TSRC PART 2
A.0 - INTERPRETATION

TSRC
PART 2 - CLARIFICATION QUESTION
A.1.1 - Traffic

TSRC
PART 2 - CLARIFICATION QUESTION
A.1.2 - Road Geometry & Road Safety

# Technical State Clarification Questions – NEXUS (03.02.02.19)

TSRC
PART 2 - CLARIFICATION QUESTION
A.1.7 - Structures
Attachment for T31

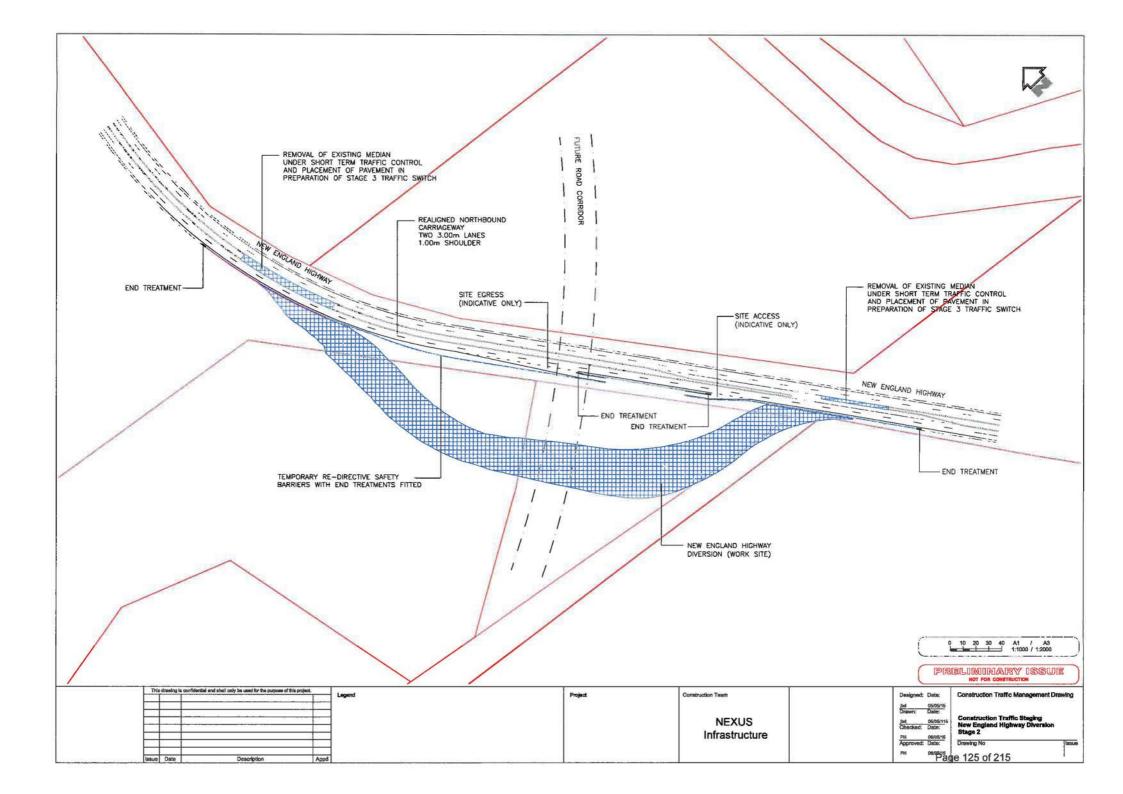
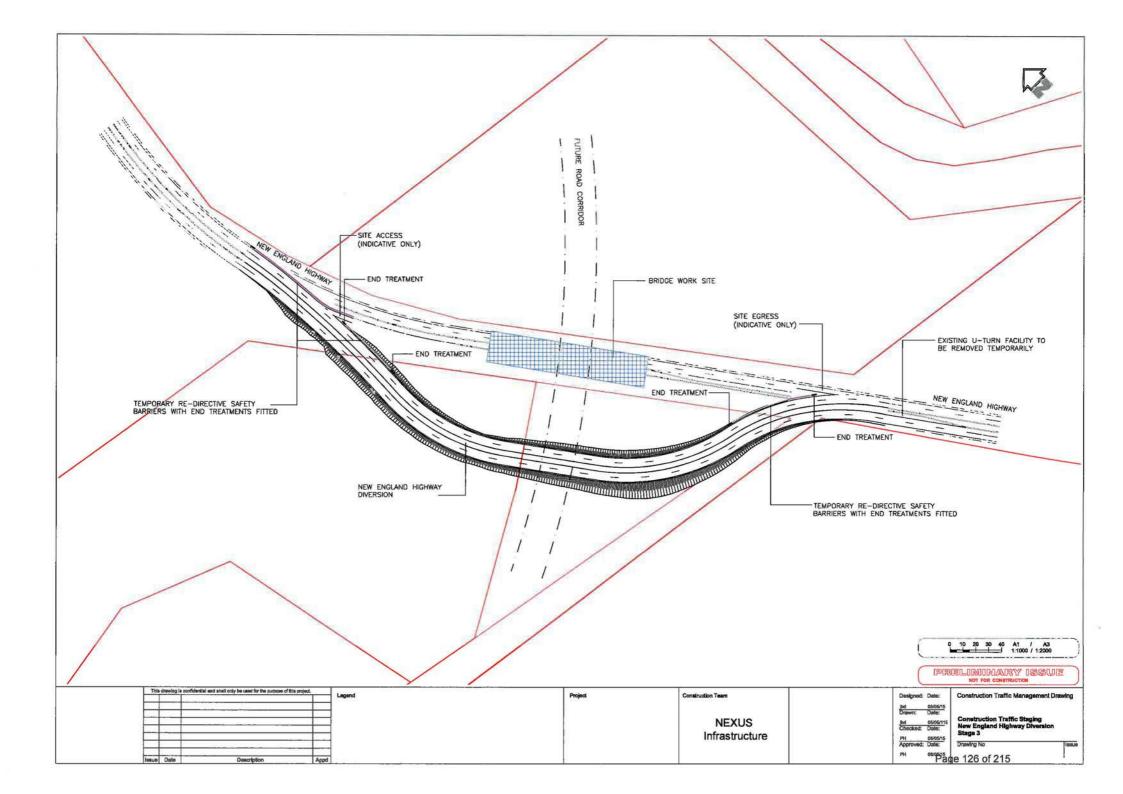
T31	A1.7	Volume 4 Returnable Schedule, Element S1 NX-BR09 - Gowrie Creek Bridge BR09-01	We are unable to fully identify the bridge inspection access and maintenance access procedures and clearances that are required in accordance with Volume 4 Returnable Schedule, Element S1.  Your drawings indicate inspection platforms at each abutment, however safe access paths to inspection platforms and safety barriers/handrails are not shown.  Please either identify the location of this information within your Proposal or provide the information in response to this question.	Bridge inspection access and maintenance access where there is a spill through abutment, including at Gowrie Creek bridge, will be detailed in accordance with TMR standard drawing 1542 / 1543.  For ease of reference we have included these drawings as Appendix T31 to this response.  Safe access paths to the platforms consistent with these standard drawings will be developed during detailed design.

TSRC
PART 2 - CLARIFICATION QUESTION
A.1.7 - Structures
For T126 Attachment refer to
Drawings

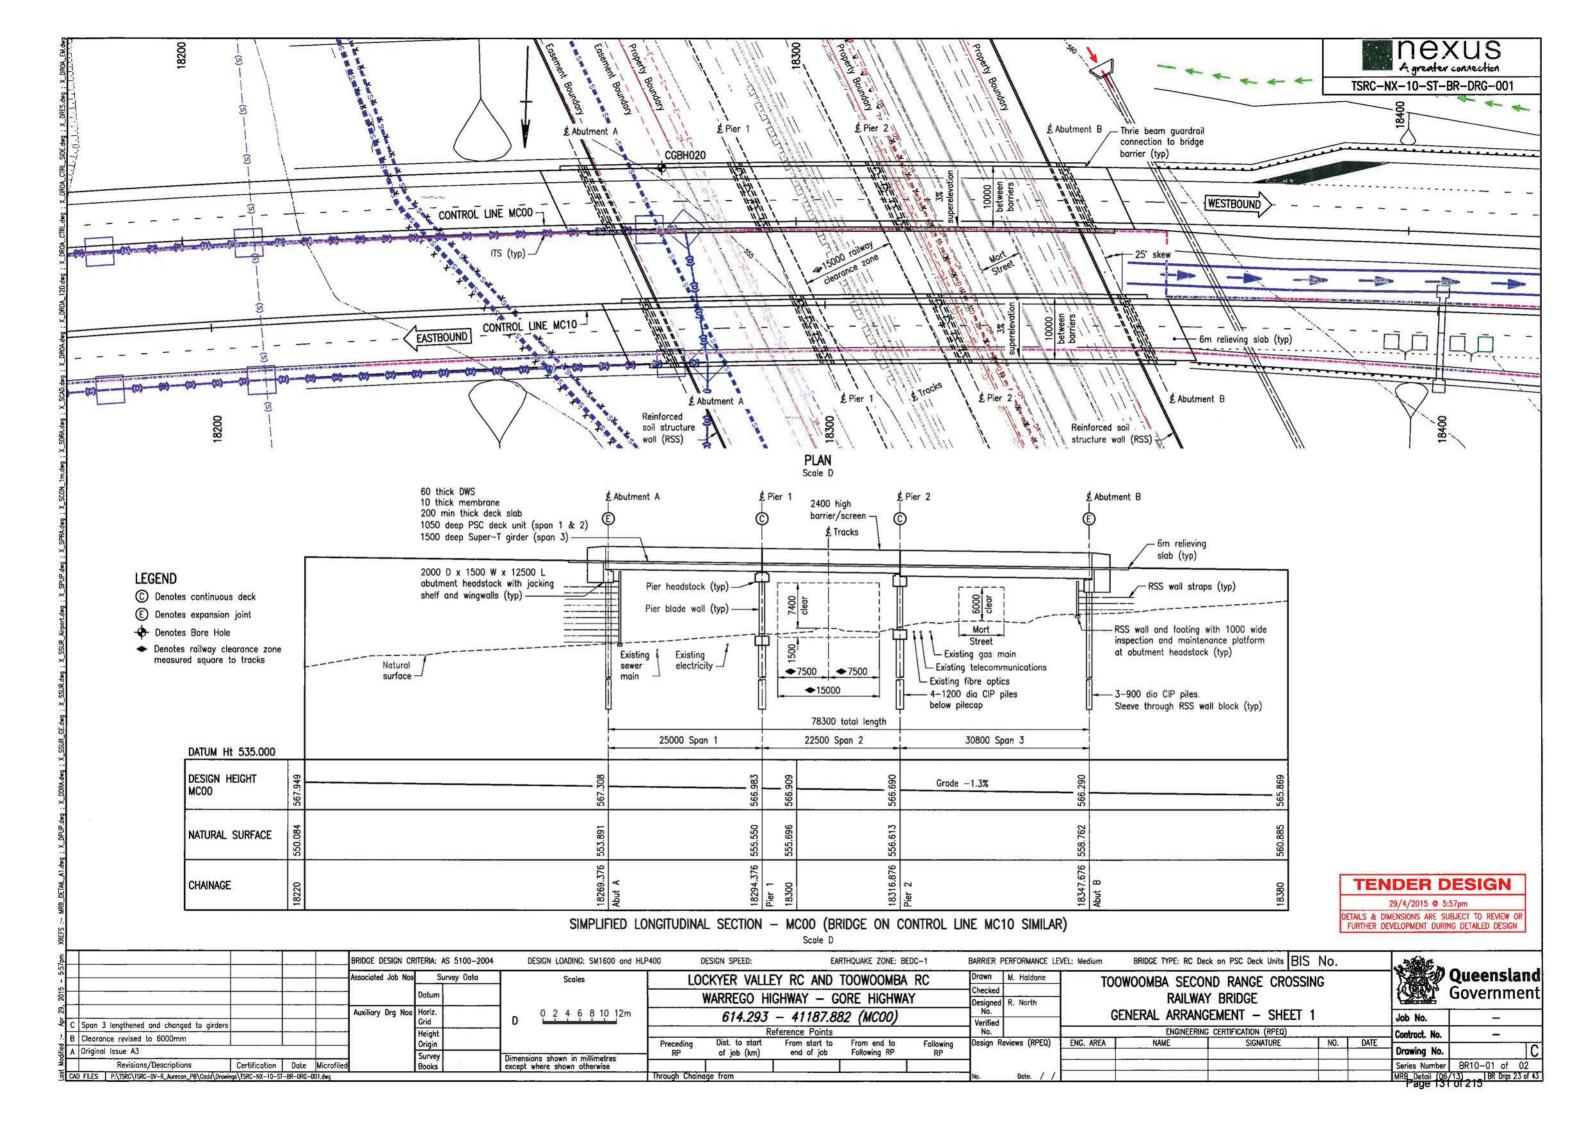
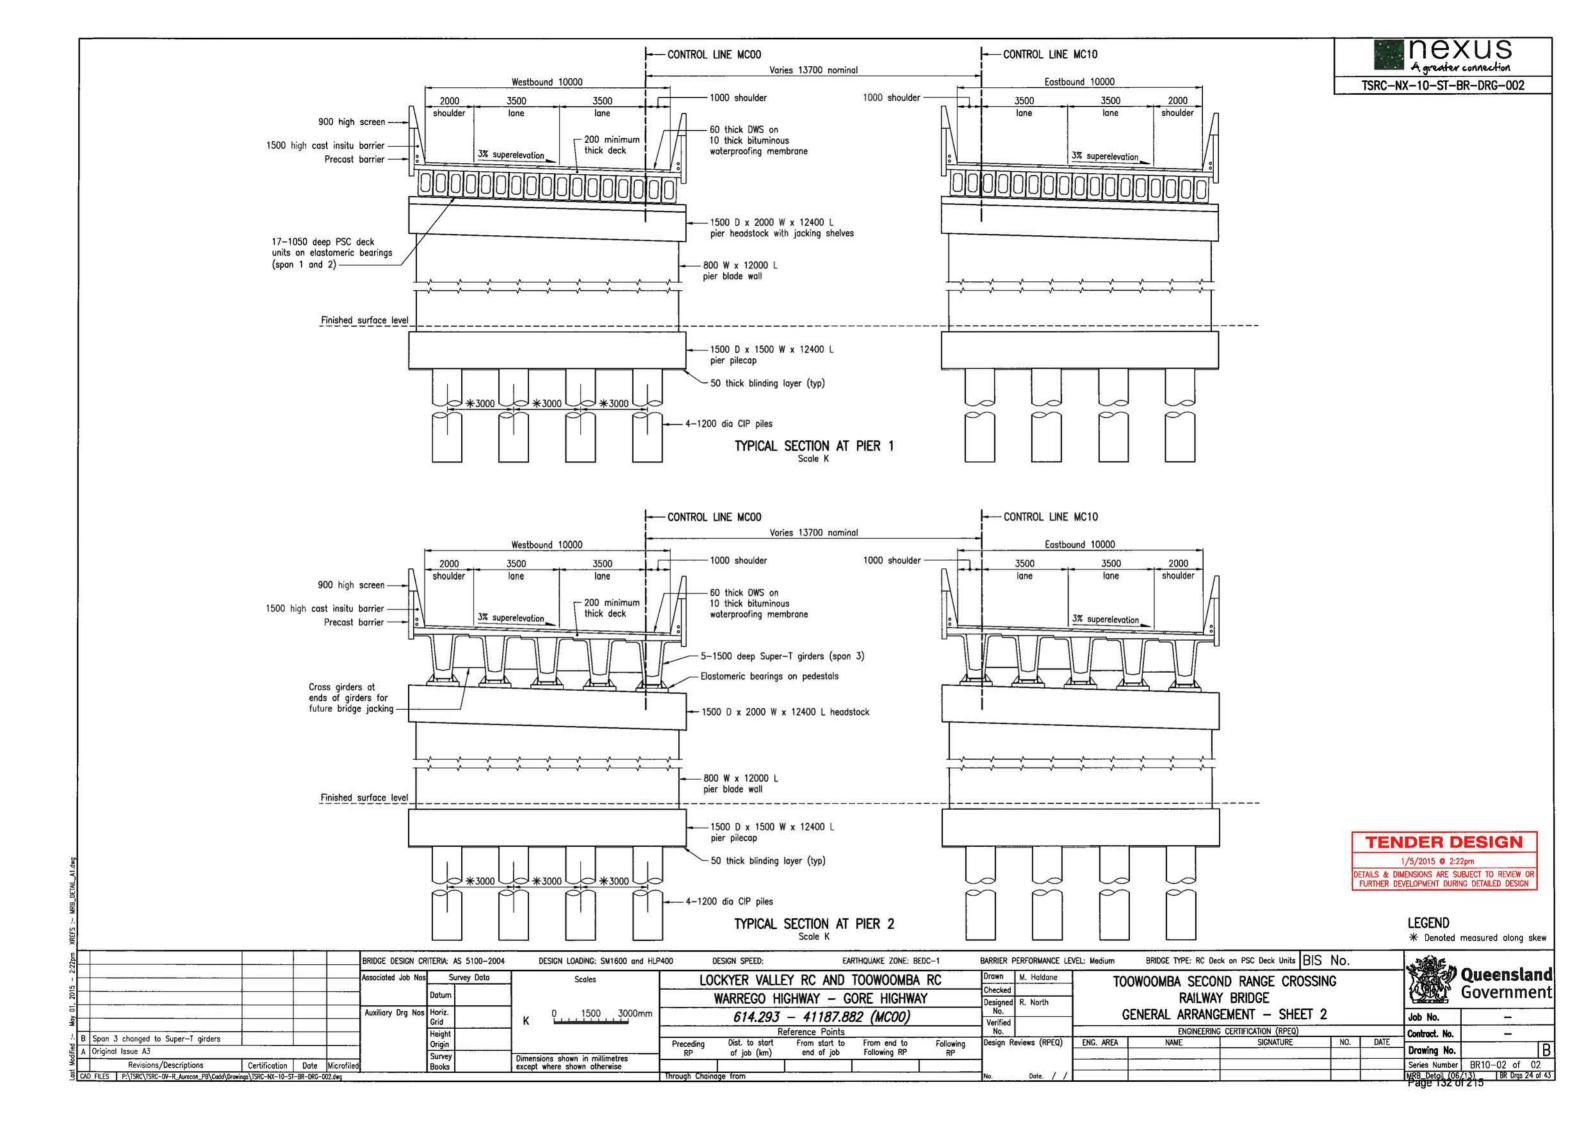
Question ID	Report Reference	Performance Specification Reference	Question	Proponent Response						
T125	Volume 4 Returna T125 A1.7 Schedule, Element and Exhibit A Table		Pursuant to Toowoomba Regional Council's (TRC) Toowoomba Regional Planning Scheme (TRPS), the proposed bridge over Gowrle Junction Road (BR13) needs to consider the TRC requirements for an upgraded Gowrle Junction Road/Ganzer Road/Holmes Road Intersection. A minimum clear width between bridge abutment walls of 47.0m is required, with provision for a central bridge support at 22.6m from the eastern abutment within a central median separation.  Please provide an updated or alternative design, noting additional costs and associated implications for changing the form of this bridge including potentially modifying the span arrangement from 3-spans to a 2-span bridge to provide at least a clear width of 47m. Refer attached (X16 - TWB1113-03-Issue 4) which demonstrates the clear width that is required at road level to achieve the future upgrade.	The impact in D&C cost is: \$517,000.00  There is no impact on Operations and Maintenance costs or Capex costs m

T126	A1.7	Volume 4 Returnable Schedule, Element S1 and Exhibit A Table 3-1	Pursuant to Toowoomba Regional Council's (TRC) Toowoomba Regional Planning Scheme (TRPS), the proposed bridge over O'Mara Road (BR16) needs to consider the TRC requirements for an upgraded O'Mara Road/Meehan Road Intersection. A minimum clear width between bridge abutment walls of 48.0m is required, with provision for a central bridge support at 24m from the eastern abutment within a central median separation.  Please provide an updated or alternative design, noting additional costs and associated implications for changing the span arrangement of this bridge to provide at least a clear width of 48m. Refer attached 'X17 - TWB1113-02-Issue 4' which demonstrates the clear width that is required at road level to achieve the future upgrade.	The impact in D&C cost is: \$621,000.00  There is no impact on Operations and Maintenance costs or Capex costs.

TSRC
PART 2 - CLARIFICATION QUESTION
A.1.7 - Structures
For T130 Attachment refer to
Drawings

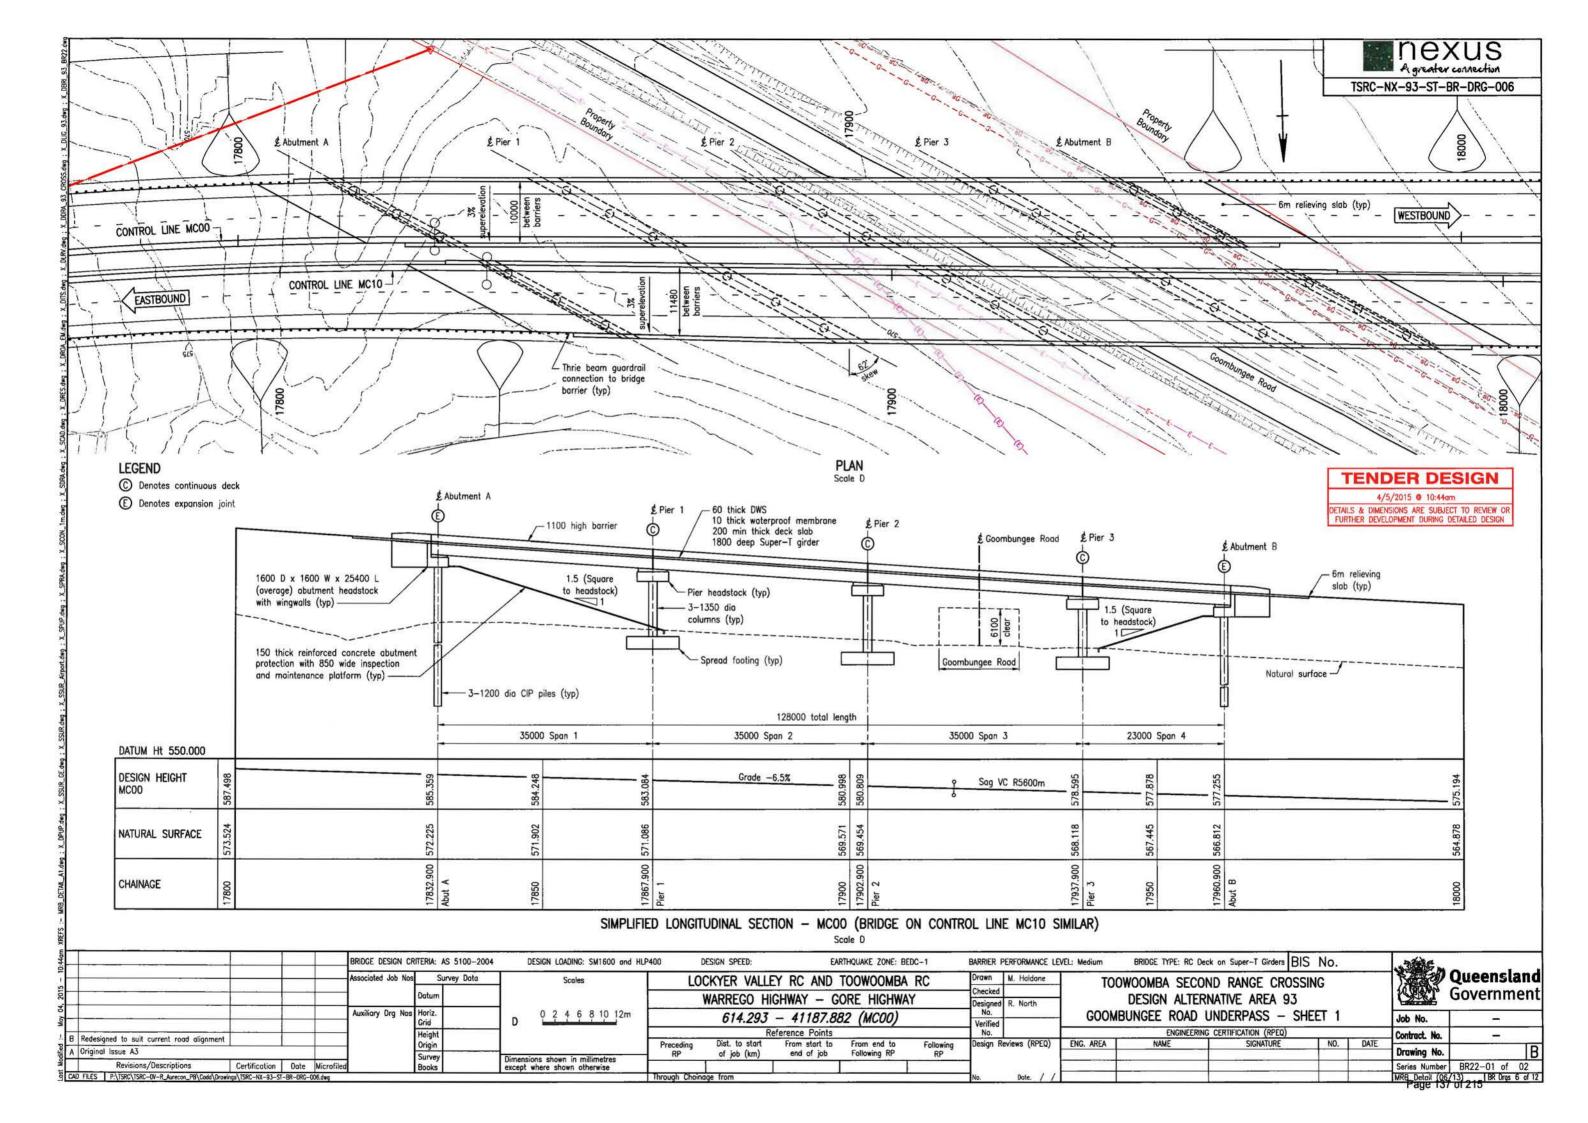
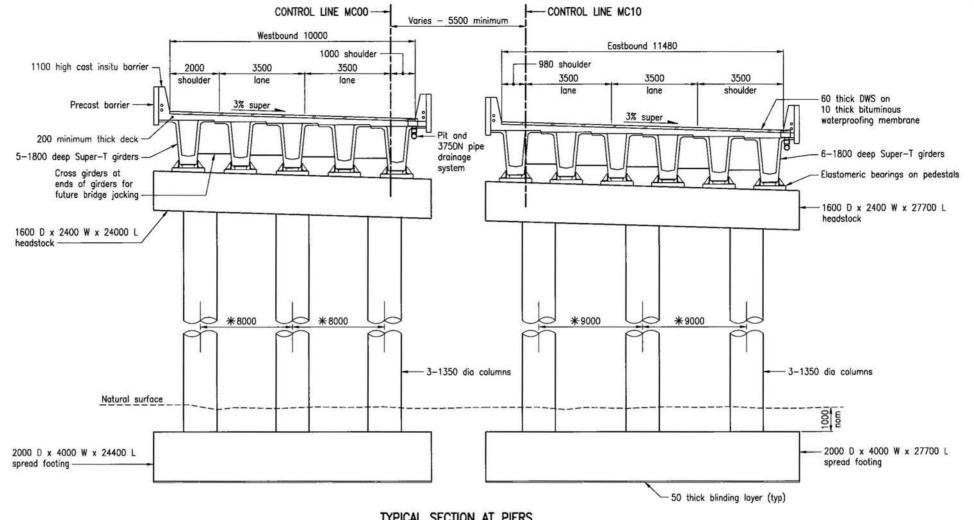
T128	A1.7	Volume 4 Returnable Schedule, Element S1 and Exhibit A Table 3-1	Pursuant to Toowoomba Regional Council's (TRC) Toowoomba Regional Planning Scheme (TRPS), the proposed Boundary Street Bridge (BR12) over the TSRC needs to consider the TRC requirements for two 3m wide footpaths to be provided, with one on each side of this bridge. A minimum clear width of 15m for the bridge is required for the provision of installing future services.  Please provide an updated or alternative design, noting additional costs and associated implications for increasing the clear width of this bridge structure from 9m to at least 15m. Refer attached 'X18 - TWB1113-01-Issue 5' which demonstrates the clear width that is required at road level to achieve the future upgrade.	To comply with the new TRC requirements the bridge has been revised as per the sketch attached as Appendix T128.  The impact in D&C cost is: \$2,188,000.00  There is no impact on Operations and Maintenance costs or Capex costs.

T129	A1.7	Volume 4 Returnable Schedule, Element S1 and Exhibit A Table 3-1	Pursuant to Toowoomba Regional Council's (TRC) Toowoomba Regional Planning Scheme (TRPS), the proposed bridge over Willet Road (BR14) needs to consider the TRC requirements for a minimum clear width between bridge abutment walls of 15m for the provision of installing future services.  Please provide an updated or alternative design, noting additional costs and associated implications for increasing the length of this bridge structure to achieve a 15m clear width between abutment RSS walls. Refer attached 'X18 - TWB1113-01-issue 5' which demonstrates the clear width that is required at road level to achieve the future upgrade.	To comply with the new TRC requirements the bridge has been revised as per the sketch attached as Appendix T129.  The impact in D&C cost is: \$110,000.00  There is no impact on Operations and Maintenance costs or Capex costs.

T130	A1.7	Volume 4 Returnable Schedule, Element S1 and Exhibit A Table 3-1	Pursuant to Toowoomba Regional Council's (TRC) Toowoomba Regional Planning Scheme (TRPS), the proposed bridge over the FGG Coupers Road (BR19) needs to consider the TRC requirements for a minimum clear width between bridge abutment walls of 19m required for the provision of installing future services.  Please provide an updated or alternative design, noting additional costs and associated implications for changing the form of this bridge including modifying the proposed span arrangement from 3-spans to a single span bridge and utilising abutment RSS walls instead of a spill-through abutment to provide at least a clear width of 19m. Refer attached 'X18-TWB1113-01-Issue 5' which demonstrates the clear width that is required at road level to achieve the future upgrade.	The Impact in D&C cost is: \$187,000.00						
T131	A1.7	Volume 4 Returnable Schedule, Element S1 and Exhibit A Table 3-1	Pursuant to Toowoomba Regional Council's (TRC) Toowoomba Regional Planning Scheme (TRPS), the proposed bridge over the Goombungee Road Underpass (BR22) needs to consider the TRC requirements for a minimum clear width between bridge abutment walls/pier supports of 25m required for the provision of installing future services.  Please provide an updated or alternative design, noting additional costs and associated implications for changing the form of this bridge including modifying the proposed bridge structure and abutments to provide at least a clear width of 25m. Refer attached 'X18 - TWB1113-01-Issue 5' which demonstrates the clear width that is required at road level to achieve the future upgrade.	The impact in D&C cost is: \$170,000.00
